PRODUCT BULLETIN # 16570

TITLE: Shipping Tube change for SOIC Wide Body (SOIC WB) devices at ON Semiconductor Carmona, Philippines

PRODUCT BULLETIN #16570

Figure1. Details of change

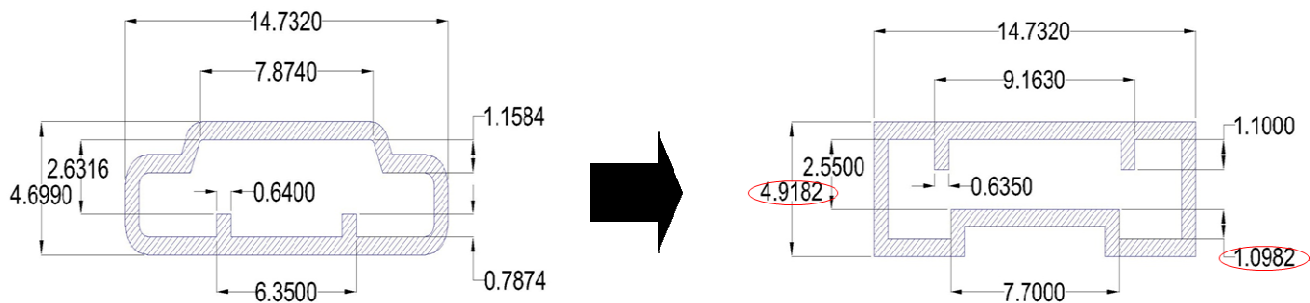
ON Semiconductor Carmona is changing the shipping tube used for SOIC WB packages. This includes dimension change within the JEDEC specification and supplier change. The change is considered as a quality and packaging robustness improvement.

- Length = 20.000 ± 0.050 inch
- End plug on both ends
- Supplier: ITW Ampang, Laguna, Philippines

- Length = 20.6751 ± 0.050 inch
- Crimp at one end
- Supplier: YOSIKO, Bulacan, Philippines
